The University of Sydney  
Business School  
Abercrombie Precinct  
Redevelopment

Response to Department of  
Planning's comments

July 2012

*Main entrance perspective*

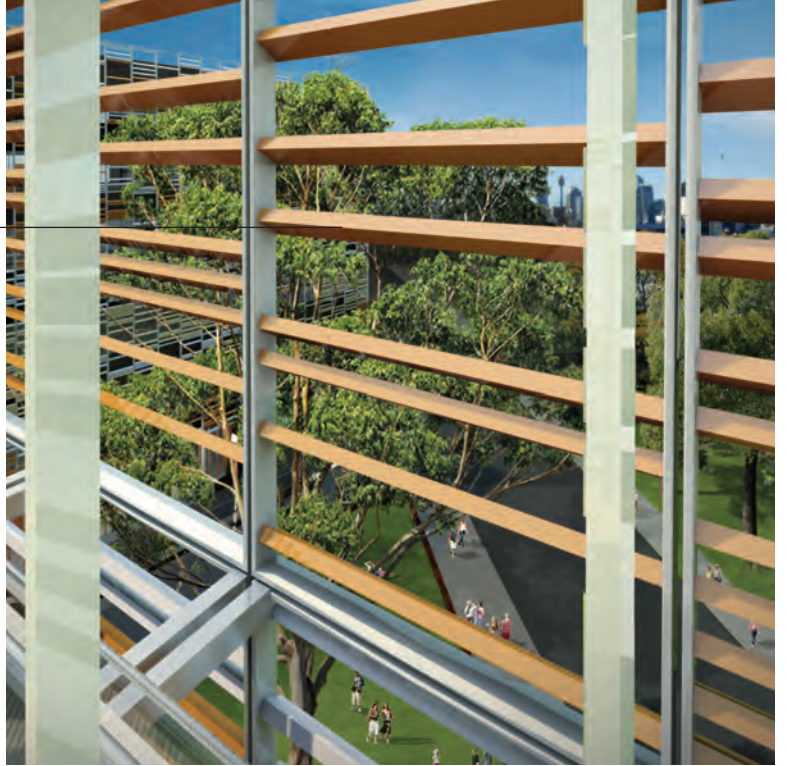
The transparent facade treatment of the terraces on Levels 4 and 5 of the business school building is considered to add unnecessary bulk to the proposed design of the new business school building. The department requests that this facade design feature be further refined to reduce its influence on the bulk of the built form whilst maintaining the character of the development's overall facade.

The continuity of the façade screen extending to the upper levels on the two front blocks is fundamental to the integrity of the architectural value proposition. The front blocks provide presence and articulate the 'screened box' design concept while framing the tree and announcing the entrance to the building. When viewed from street level the impact is minimised through the angling of the baguettes. This allows a maximised exposure of sky from street level while providing the necessary shading to both the terrace and the internal spaces at the uppermost levels of the building. A play of light will occur on the baguettes as the sunlight varies in intensity and direction. The greenery of the landscaped terraces will also be visible from the ground to highlight further the openness.

Screening permeability to sky maximised with angled baguettes

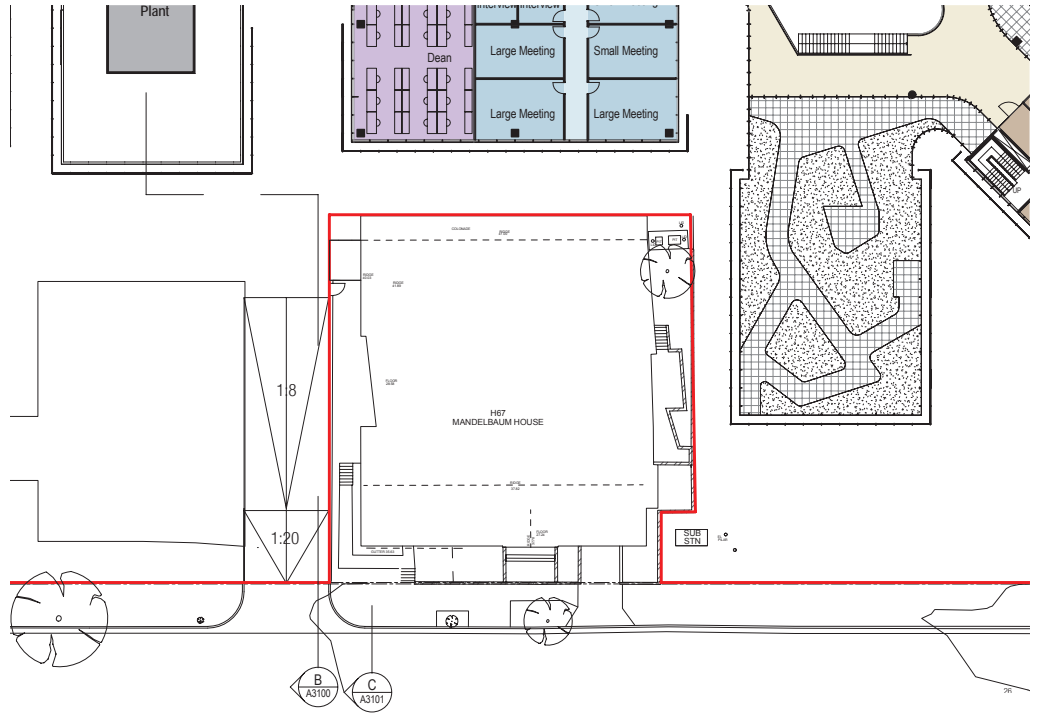
‘The upper level of the business school building, located immediately behind Mandelbaum House, should be setback back to minimise overshadowing impacts on the existing adjacent residential college.’  
and

‘Minimal consideration has been given to the potential impacts of the redevelopment on Mandelbaum House. Greater consideration and justification is required in response to the potential amenity and privacy impacts generated by the proposed development, including the significant overshadowing impacts on Mandelbaum House.’

A terrace has been introduced at level 4 (the uppermost level) of the block nearest Mandelbaum House. The terrace, which creates a 3m setback, is to be treated in the same way as the front building terraces near the Dean’s unit and the dining area where the ceramic baguettes continue as a screen to roof level . This is envisaged to increase daylight penetration when compared to the original Part 3A proposals. Overlooking is minimised through this ceramic baguette screen which can further be angled to both reflect light into the terrace area and create privacy for Mandelbaum House.

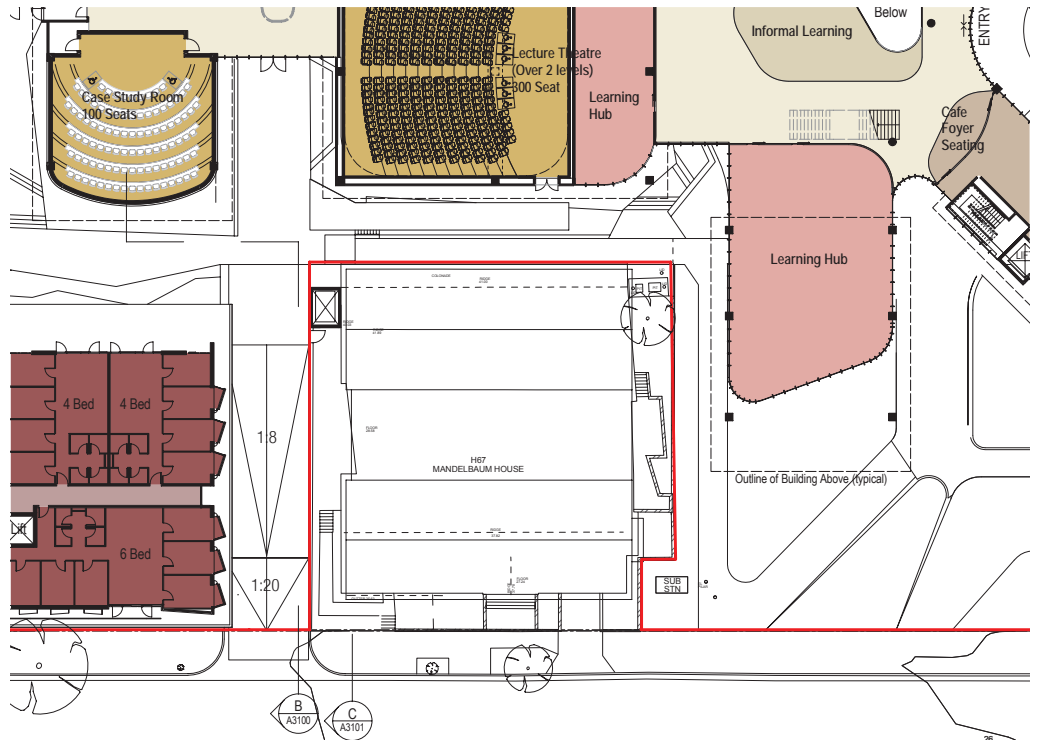
Consideration should be given to increasing the setback of the proposed basement car park vehicle access to a minimum 3.0 m from the existing property boundary of Mandelbaum House. Should the proposed basement car park access be retained in this location on Abercrombie Street, the increased setback will allow for the either retention of the some of the existing Crow Ash trees and/or the establishment of a suitable mature replacement species, which will ensure that the existing green outlook from the existing residential college is maintained.

The vehicle access ramp is now positioned within the student housing building. This allows for a setback of 9.5m from Mandelbaum Façade to the student accommodation building façade. This enables the retention of existing trees and provides a more open pedestrian access route through the site. Furthermore, vehicle noise will be minimised as the ramp is entirely enclosed within the student housing.
